**SAN ANTONIO WATER SYSTEM
Interdepartment Correspondence Sheet**

Subject: Zoning Case Z2020-10700230 (Tradesman Warehouse Development)

Date: August 30, 2021

ZONING FILE: QUARRY RUN WAREHOUSE (FIGURE 1)
ZONING CASE: Z2020-10700230
MAP PAGE: 169, A1

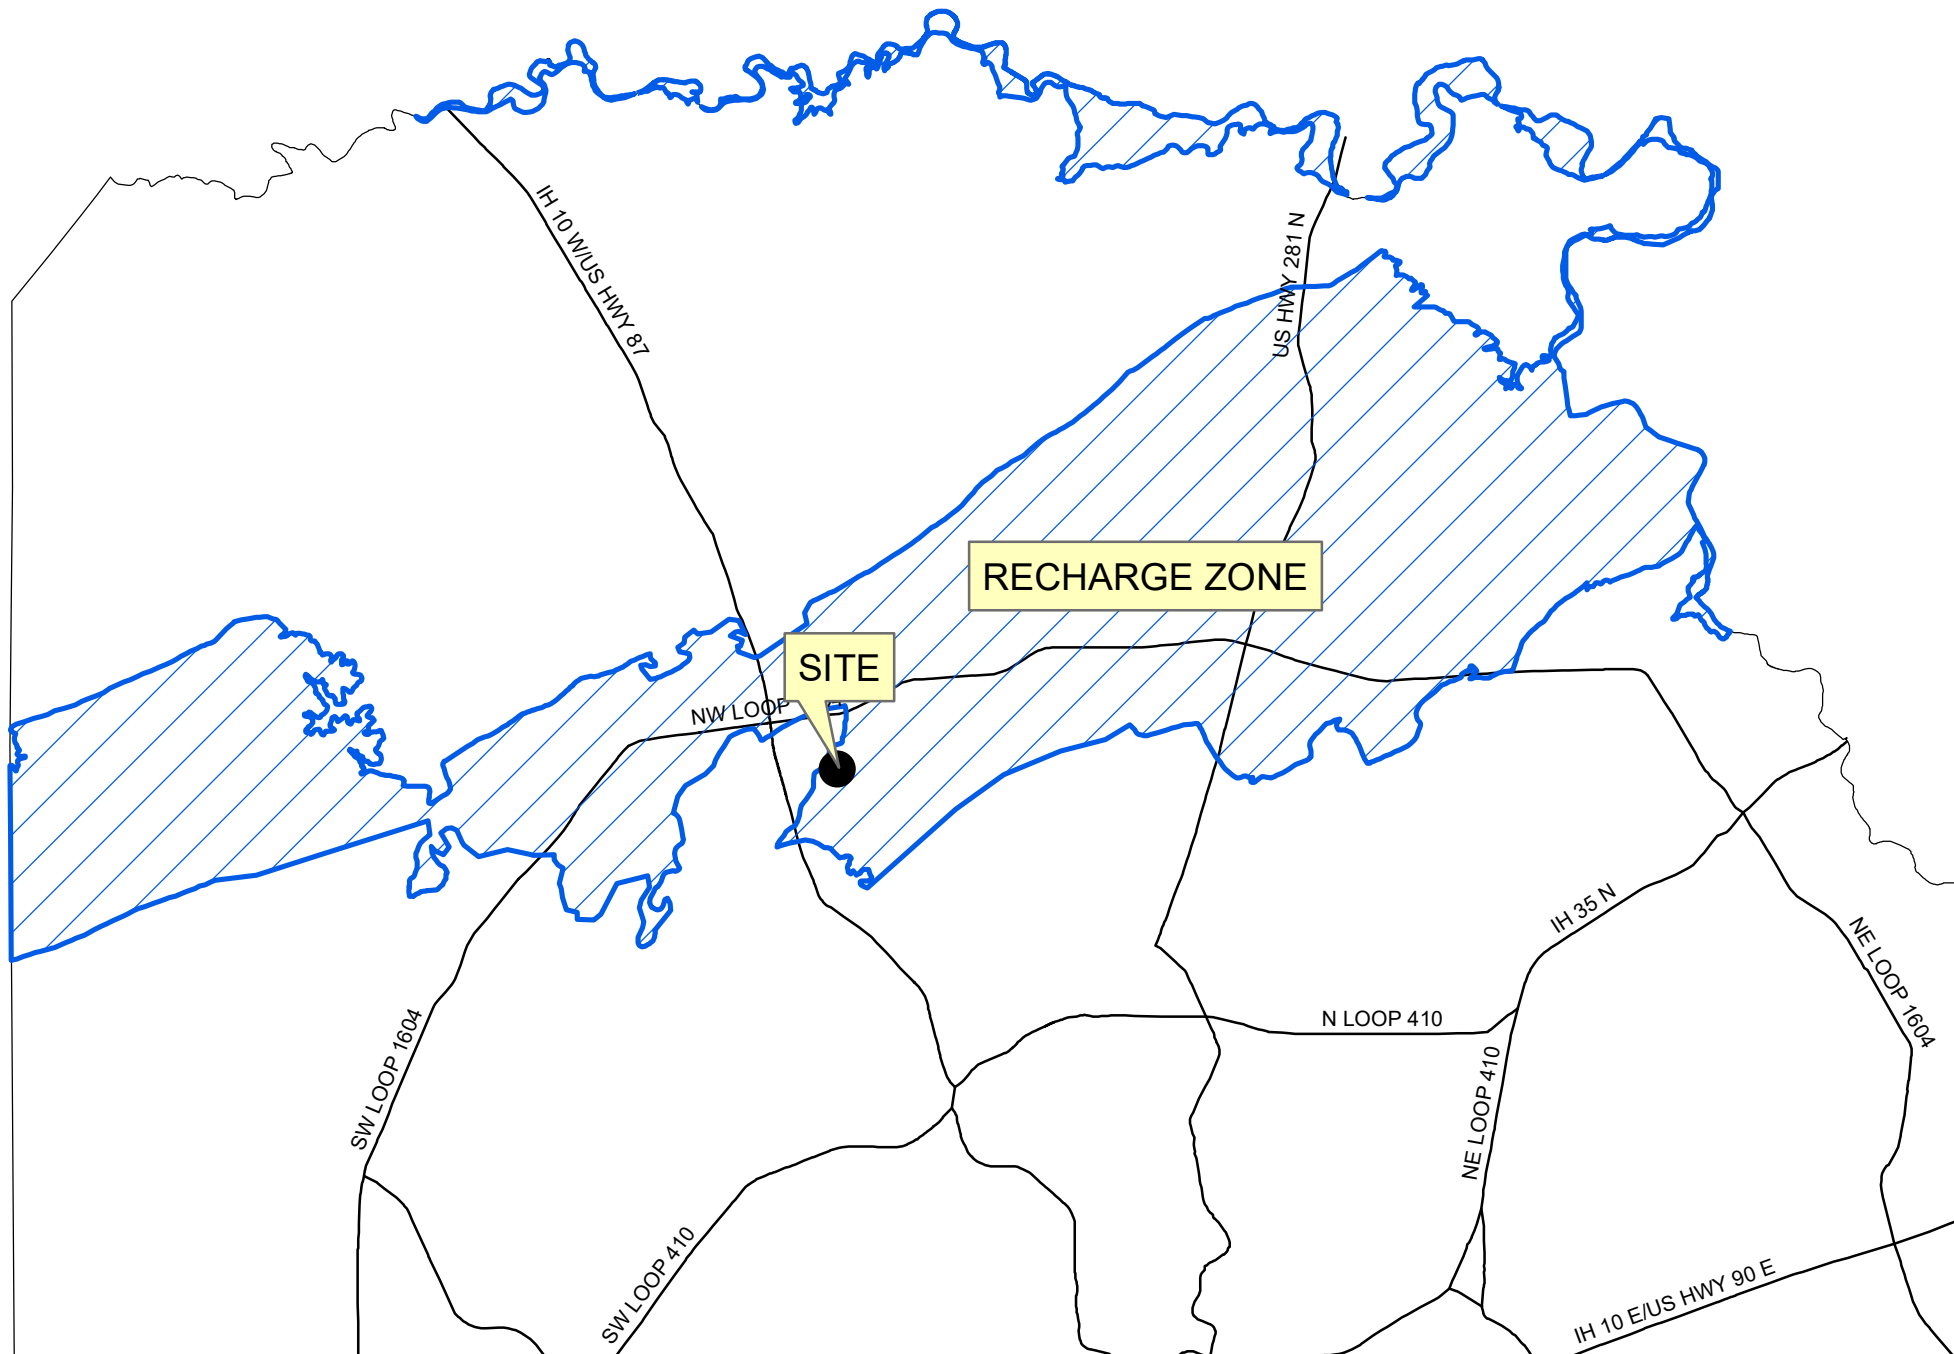
The subject property is in City Council District 8, located 650 feet south of the intersection of Tradesman Drive and Quarry Run Road. The property lies within the Edwards Aquifer Recharge Zone (Figures 1 and 2).
